**ADDENDUM NO. 1**  
**2025 ASPHALT OVERLAY PROJECT**  
**PROJECT #12525**

**ATTENTION ALL BIDDERS AND PLANHOLDERS:** You are hereby notified that the Bid and Contract Documents are amended as follows:

2025 ASPHALT OVERLAY

2025 ASPHALT OVERLAY		CITY PROJECT #:
ROADWAY AND CHANNELIZATION PLAN 5		12525
18TH AVE S - SCHEDULE		SHT. 103
430+50 - 435+32		OF 125

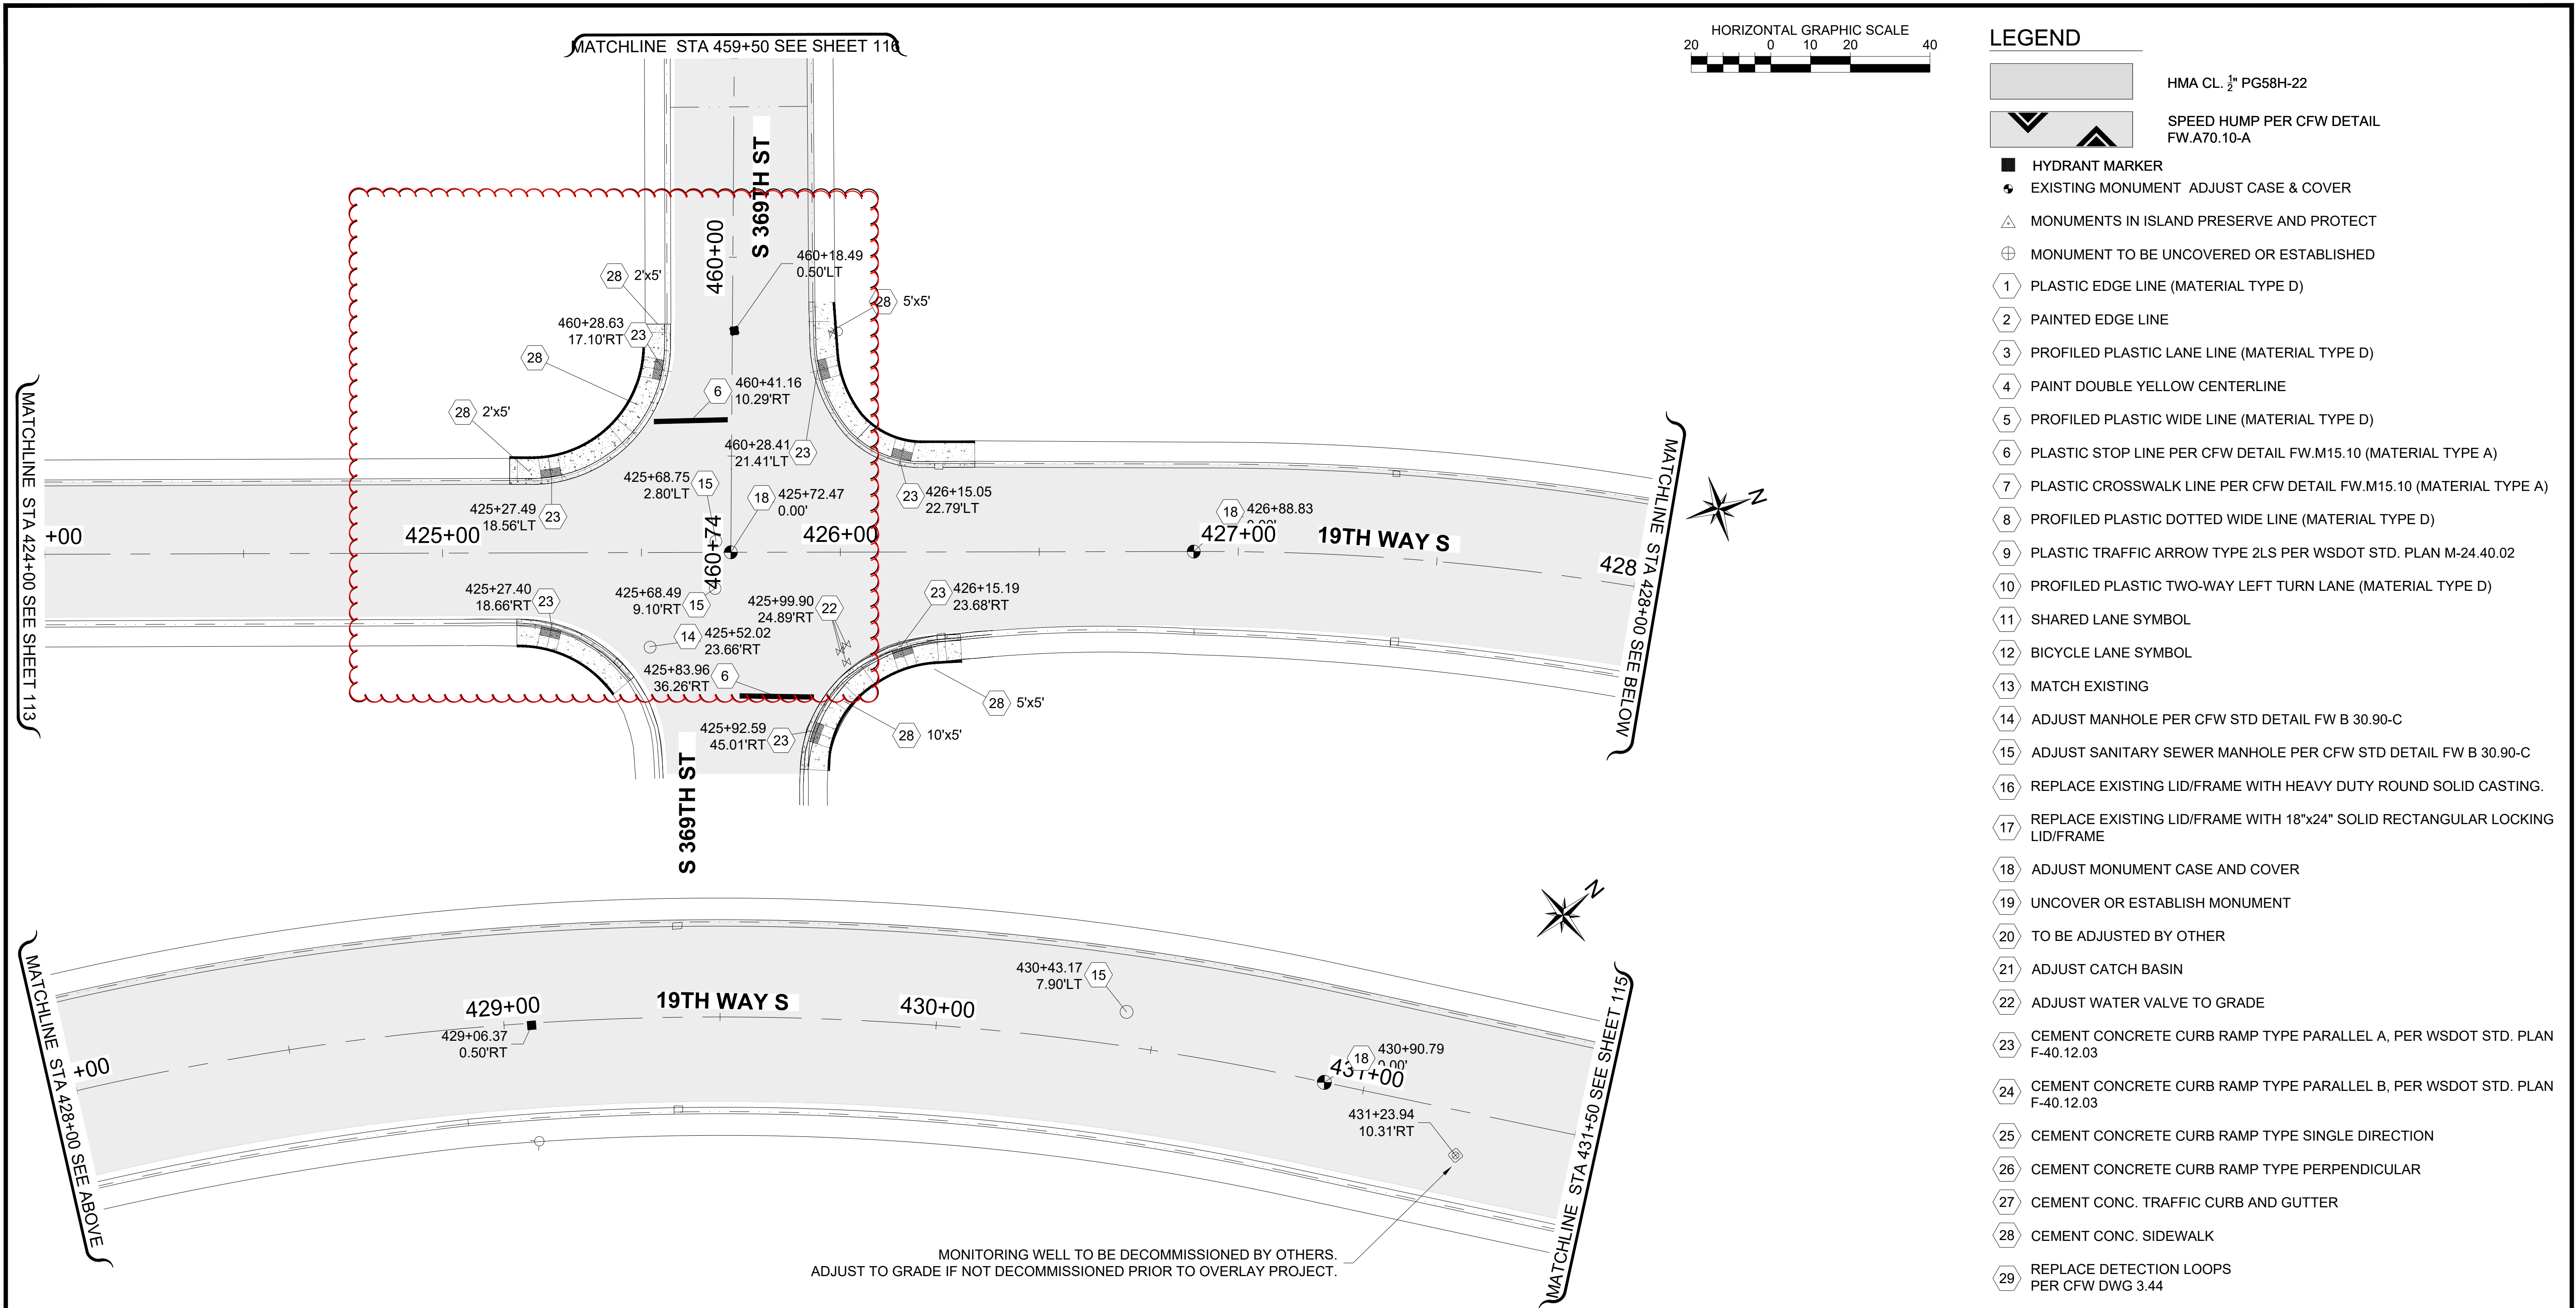
**(10) Sheet 103 of 125 Plan Set:**

- Removing 2 ramps, shortening paving limits, and removing “Induction Loop Vehicle Detection System”
